## **STAFF REPORT**

**APPLICATION PCA 1999-HM-037  
Concurrent with SEA 97-H-070-03  
and RZ/FDP 2016-DR-001**

**APPLICANT:** NVR, Inc.

**PROPOSAL:** To permit the deletion of 11.95 acres from RZ 1999-HM-037 to permit the site to be rezoned to PDH-30 as part of RZ/FDP 2016-DR-001.

LOW IMPACT DEVELOPMENT EXAMPLES

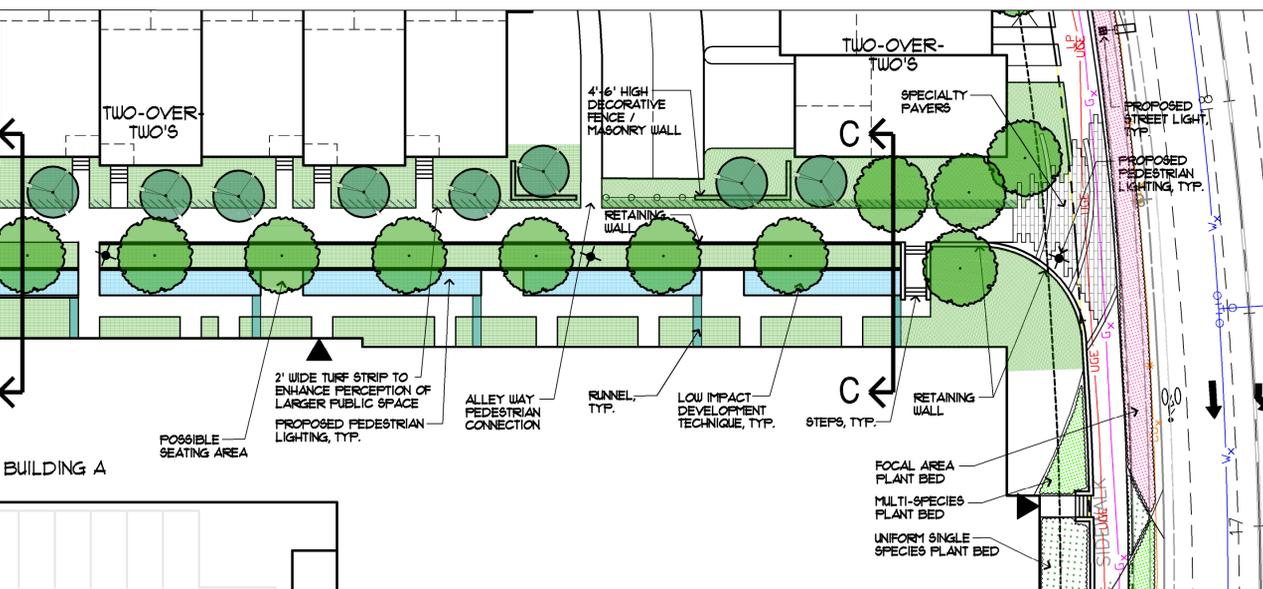
4. **Comment:** Planting beds less than eight feet wide are proposed for trees adjacent to walkways in the pedestrian promenade as shown on plans and in LID sections B and C on Sheet 13. Planting beds for trees should be a minimum of eight feet wide to satisfy PFM requirements.

Figure 2-Site Layout- CDP/FDP Sheet 6

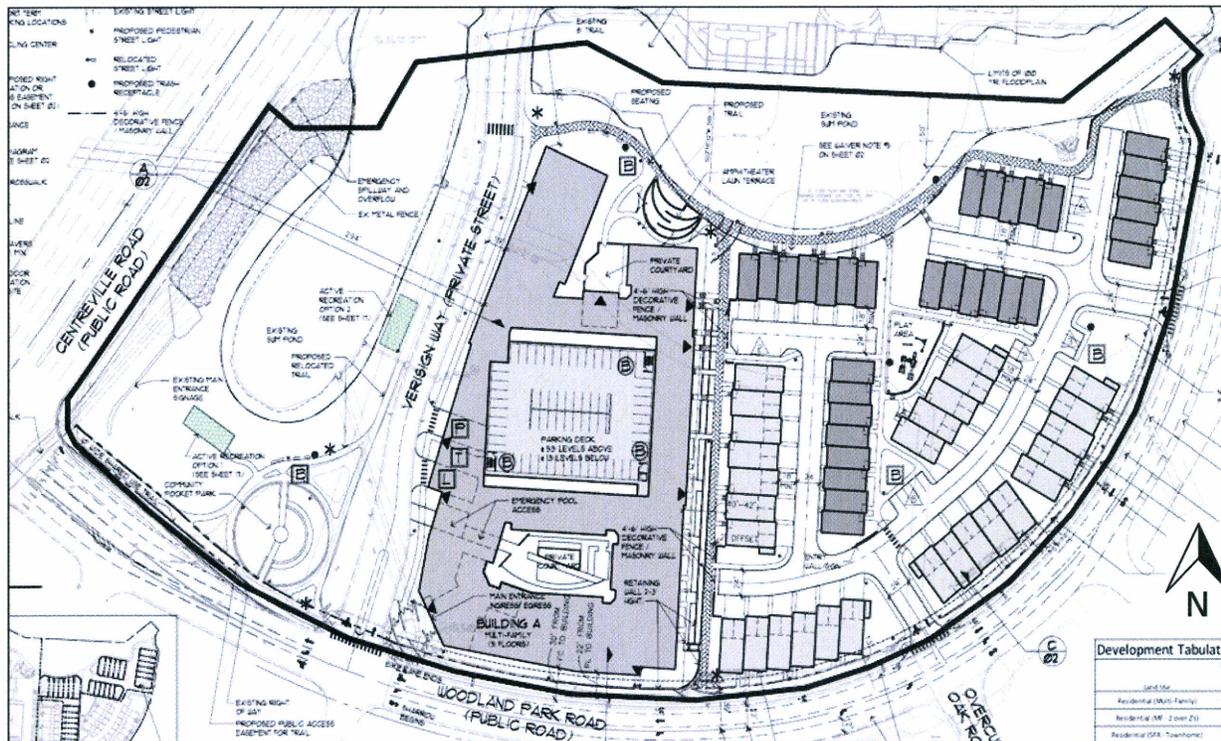
- a. Staff is in support of a maximum of 4' depth for driveways not used for parking, as described in the draft proffers and driveway enlargements shown on sheet 6. However, the CDP/FDP drawing on sheet 6 is inconsistent with this statement, showing several driveways that will not accommodate parking but show a 7' dimension. The applicant should revise this drawing to ensure consistency with all other application materials and avoid confusion at the time of Site Plan.

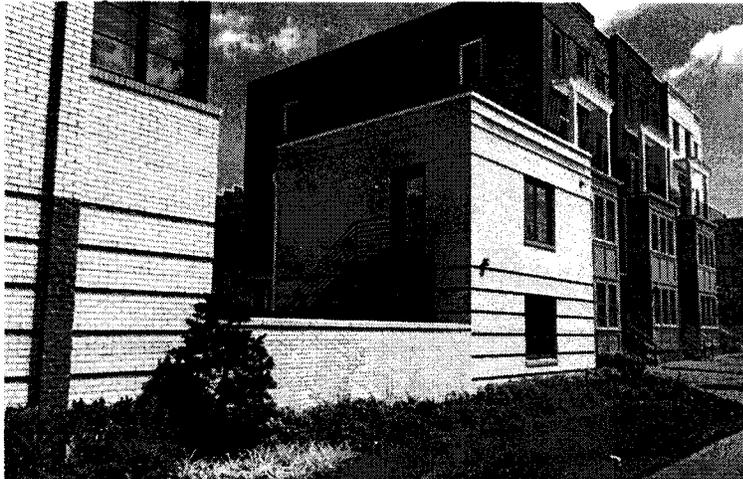
Additional information is needed regarding the proposed Woodland Park Road streetscape along the multi-family building. The submitted plans lack the streetscape section for this portion of road. Moreover, street trees are not reflected on the CDP/FDP along the road in front of the multifamily building. Street trees should be provided as recommended by the Comprehensive Plan's Urban Design recommendations, keeping in mind sight distance issues. Staff has communicated to the applicant that the provision of street trees and maintaining necessary sight distance would require the multi-family Building A to be pushed back from the road.

Verisign Way does not meet the Comprehensive Plan recommended streetscape. To address the Comprehensive Plan, sidewalks should be a minimum of 6 feet wide along the eastern length of the street. The landscape amenity panel along the street's east side should be a minimum of 8 feet wide and include street trees. The path along Verisign Way's western side should be a minimum of 8 feet in width given its function as the major regional trail recommended in the Trails Plan. In addition, this path is will likely serve as the main link between the pond and park amenities, and populations to the west and south which underscores the importance of appropriates widths for landscaping, street trees, sidewalks and trails.
